ARCHITECTURAL REVIEW

AR-17-0007

**** APPROVAL WITH CONDITIONS ****

Project: Rivercrest Meadows Apartments – Clubhouse Conversions

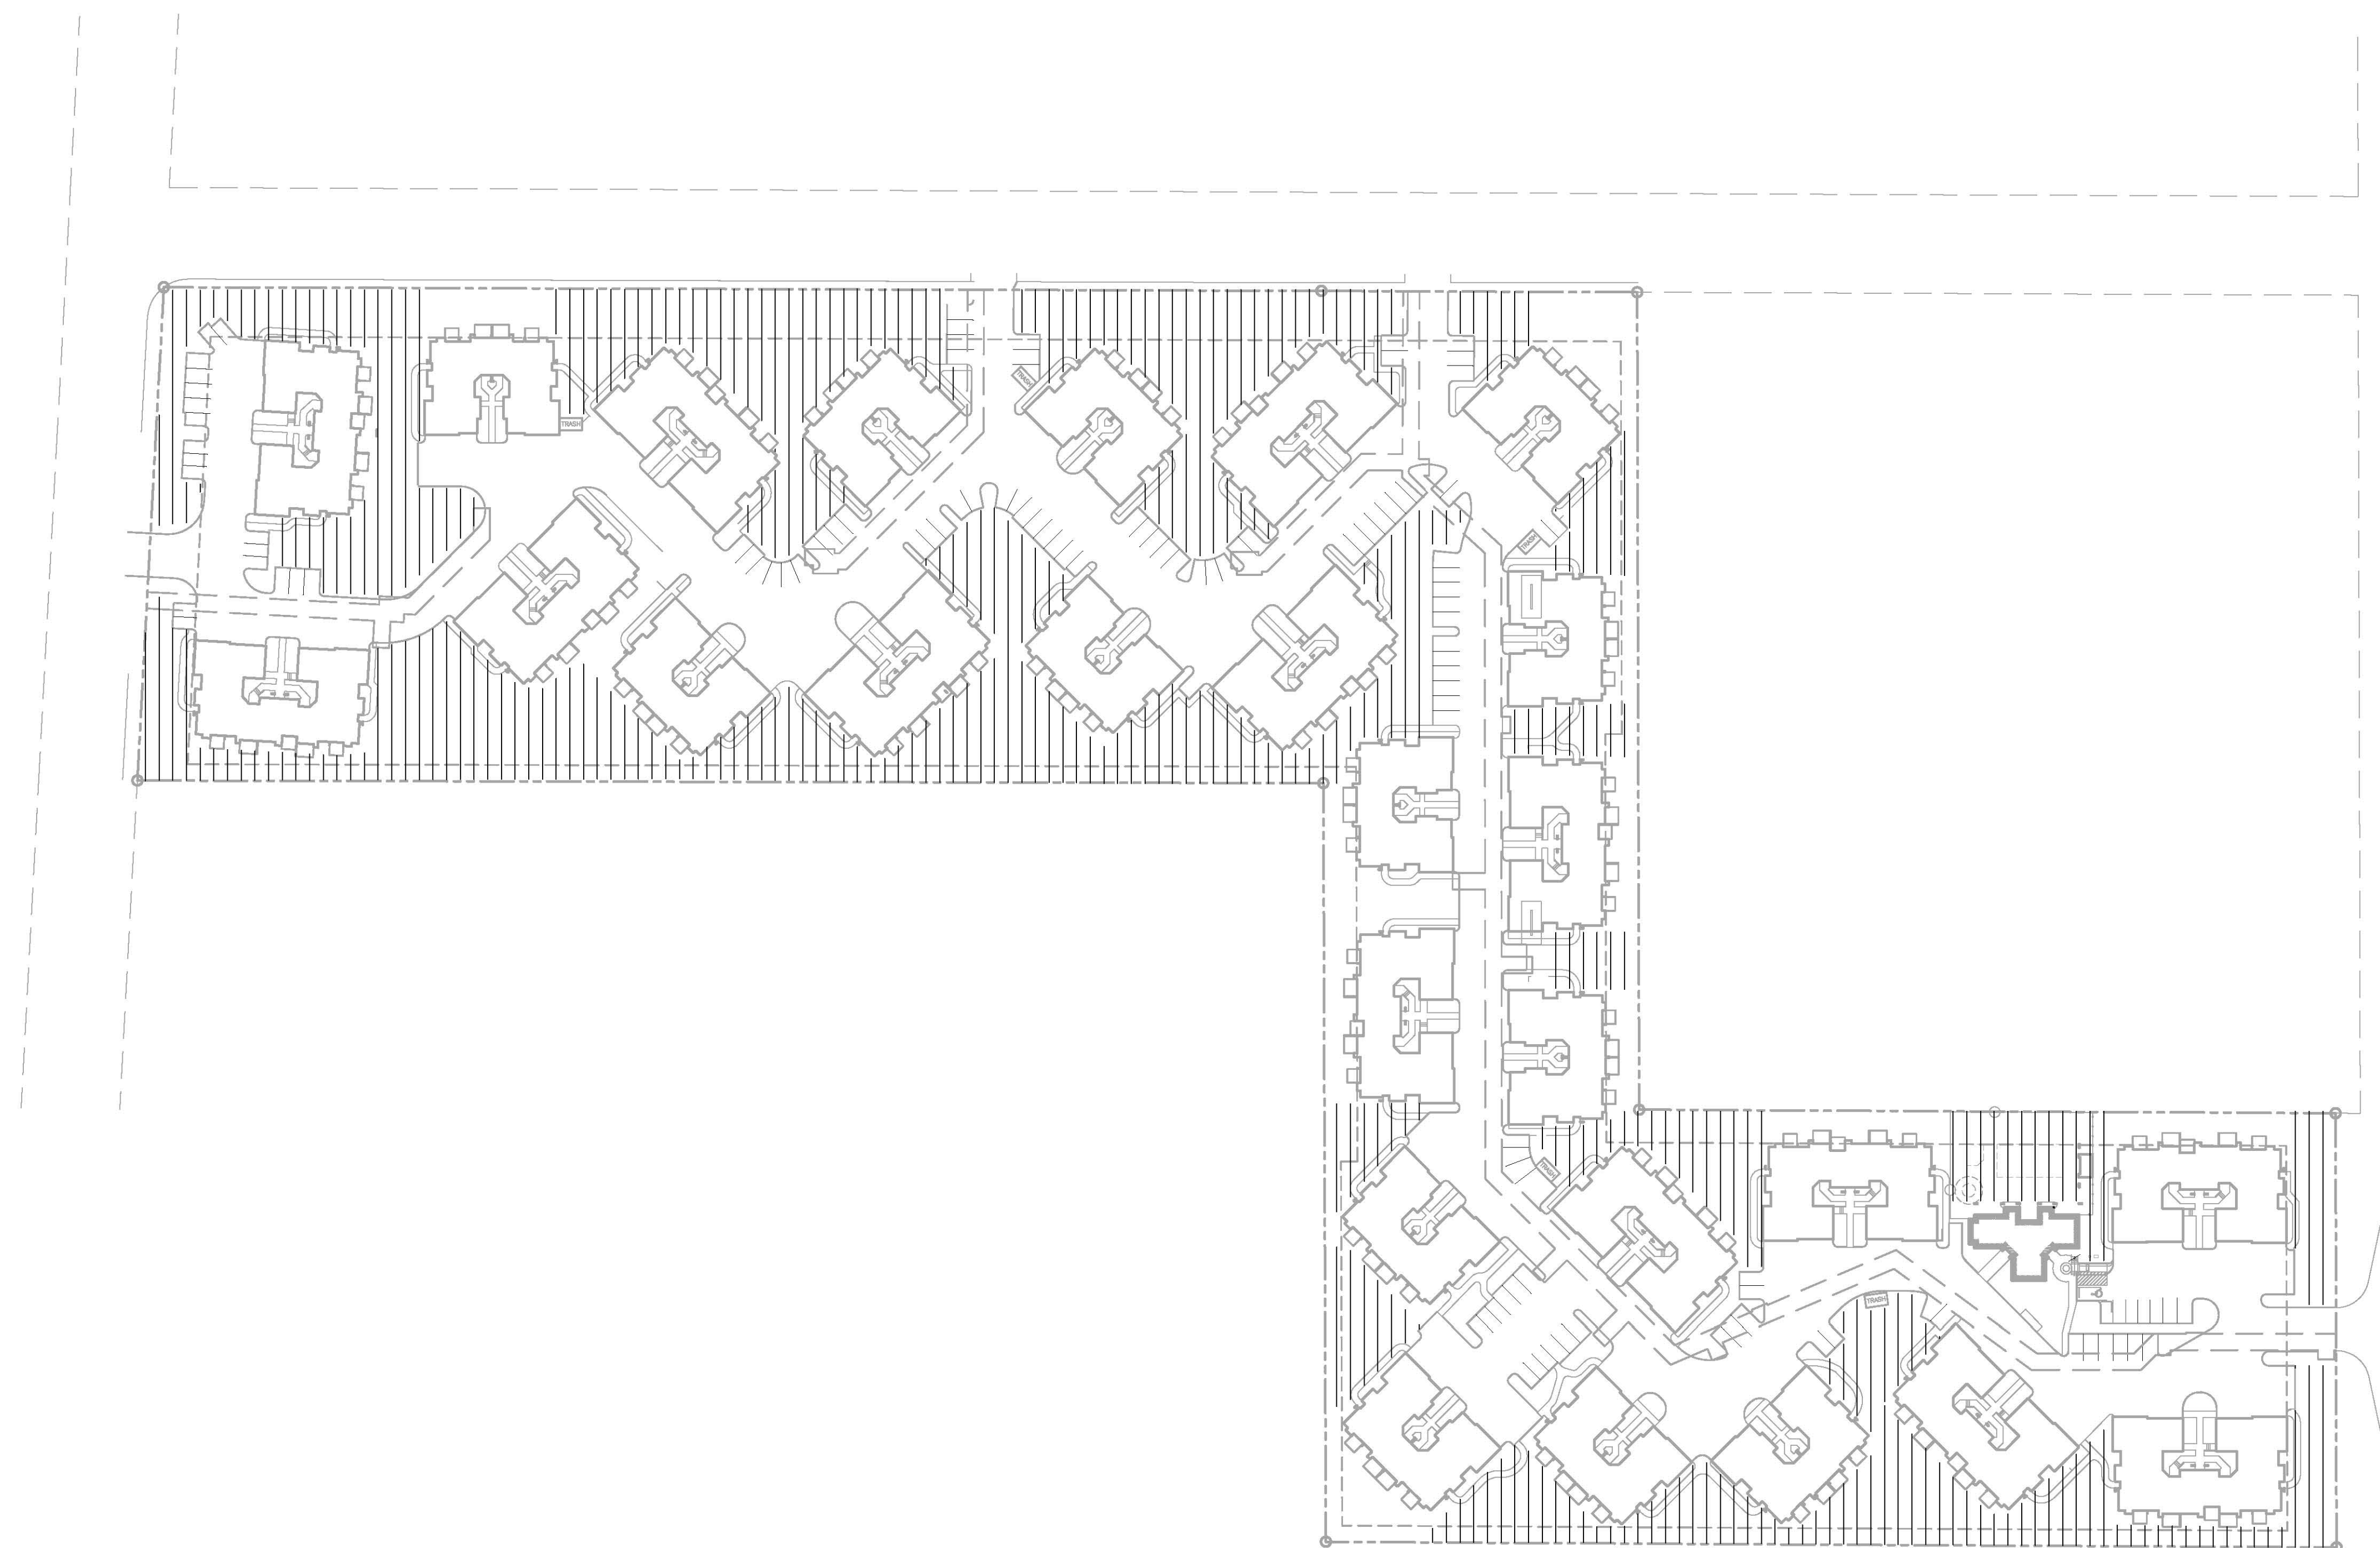
The applicant has provided Shared Outdoor Calculations Sheet A3.10, dated 12.14.17, which illustrates all common and open lawn areas provided on-site. Staff notes this calculation includes passive open lawn areas. With the exception of the 687 sq ft play turf, no other active recreation amenity has been described as part of the proposal. The applicant's narrative is also silent on the existing square footage of children's play areas provided on-site. No details have been provided in the proposal to address year-round active recreation amenities, accessibility to residents, visibility from units, separation to entry and parking areas, and materials proposed for usable floor surfaces.

Condition of Approval: The applicant must provide illustrative and written evidence that TDC 73.130(3) is met. A minimum of 1,350 square feet of shared outdoor area must be provided onsite, of which a minimum of 450 square feet shall be dedicated to children's play area.
